PLAT COMMITTEE

Case Number: 2022-PLT-071
Property Address: 1399 North Shadeland Avenue and 7007 East 14th Street (Approximate Address)
Location: Warren Township, Council District #19
Petitioner: Jaybob Inc./ Jayne McLain, by Don Fisher
Zoning: D-3, C-1, and C-3
Request: Approval of a Subdivision Plat, to be known as Replat of Lots 4, 5, and 6 of Warren Terrace Addition, dividing 2.053 acres into three lots.
Waiver Requested: None
Current Land Use: Commercial
Staff Reviewer: Allison Richardson, Senior Planner

PRELIMINARY REPLAT

WARREN TERRACE ADDITION

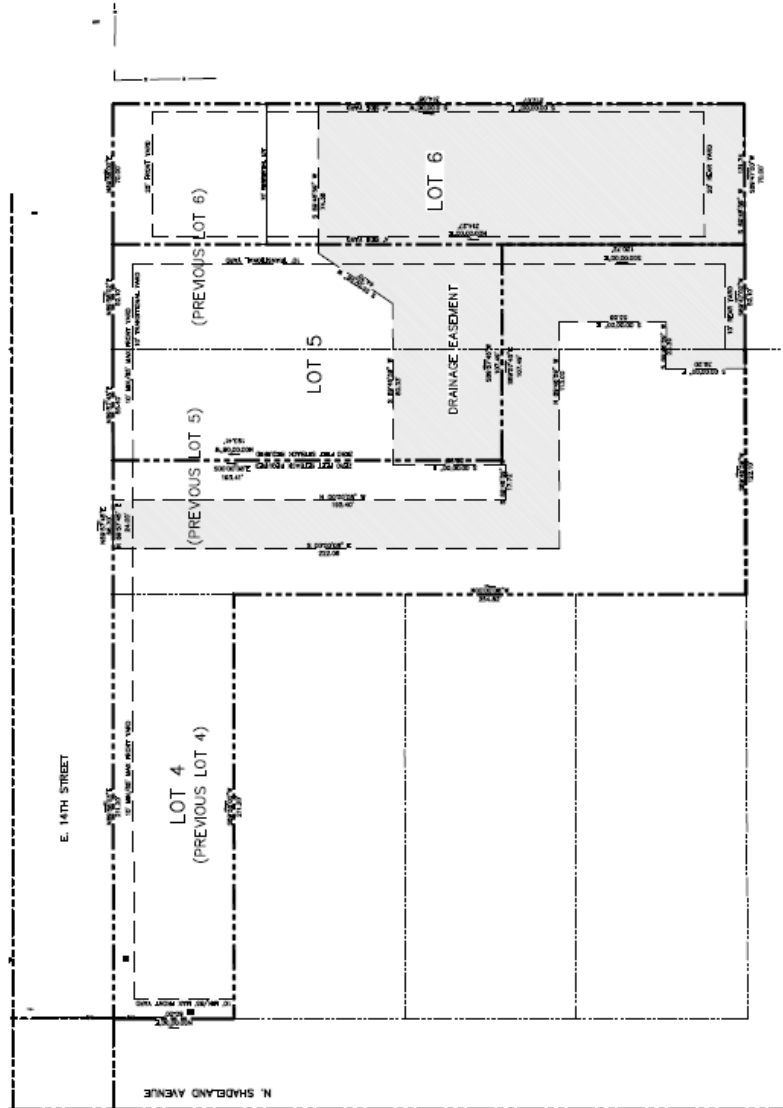
Staff recommends that the Plat Committee **approve** and find that the plat, file-dated October 6, 2022, complies with the standards of the Subdivision regulations, subject to the following conditions:

9. That the Storm Drainage Covenant (Section 741-703, of the Consolidated Zoning and Subdivision Ordinance) be affixed to the final plat prior to recording.
10. That the plat restrictions and covenants, done in accordance with the rezoning commitments, be submitted prior to recording the final plat.
11. That all the standards related to secondary plat approval listed in Sections 741-207 and 741-208 of the Consolidated Zoning and Subdivision Ordinance be met prior to recording the final plat.
12. That sidewalks must be installed along East 14th Street.

Sidewalks are existing along Shadeland Avenue and East 14th Street. The sidewalk on East 14th Street must be extended to the frontages for Lots Five and Six.
